Posted  
Correction to  
Amdt 5 to NPF-38

SUBJECT: CORRECTION OF AMENDMENT NO. 5 TO FACILITY OPERATING LICENSE  
NPF-38

Waterford 3

ATTACHMENT TO LICENSE AMENDMENT NO. 5  
TO FACILITY OPERATING LICENSE NO. NPF-38  
DOCKET NO. 50-382

FIGURE 3.2-1a

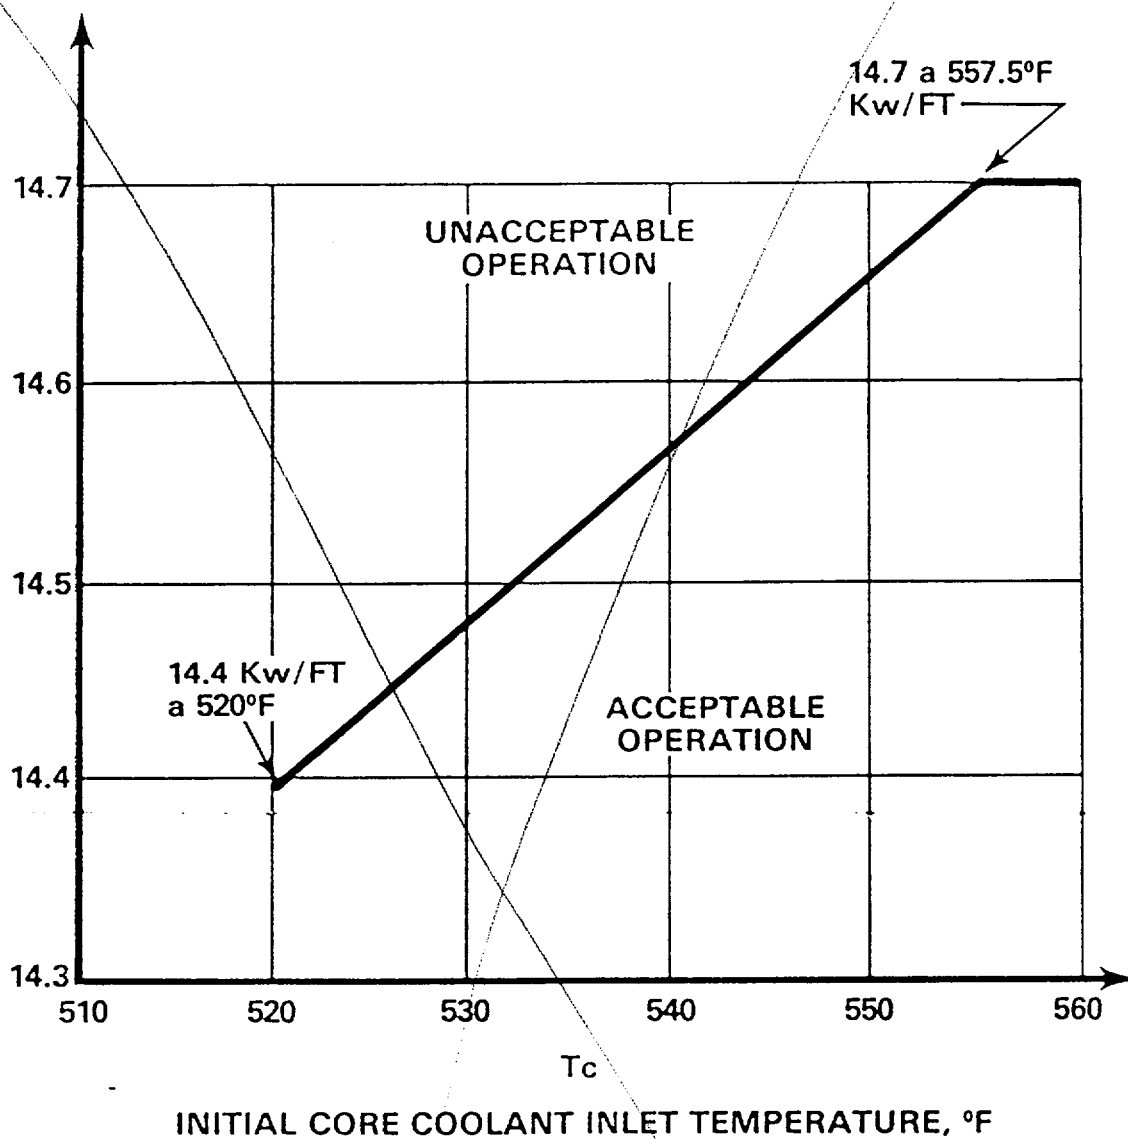
- a. Maintaining COLSS calculated core power less than or equal to COLSS calculated core power operating limit based on linear heat rate (when COLSS is in service); or
- b. Operating within the region of acceptable operation of Figure 3.2-1a using any operable CPC channel (when COLSS is out of service and either one or both CEACs is operable).
- c. Automatically by CPC (when COLSS is out of service and neither CEAC is operable).

1. COLSS calculated core power exceeding COLSS calculated core power operating limit based in linear heat rate; or
2. When COLSS is out of service, operation outside the region of acceptable operation in Figure 3.2-1a;
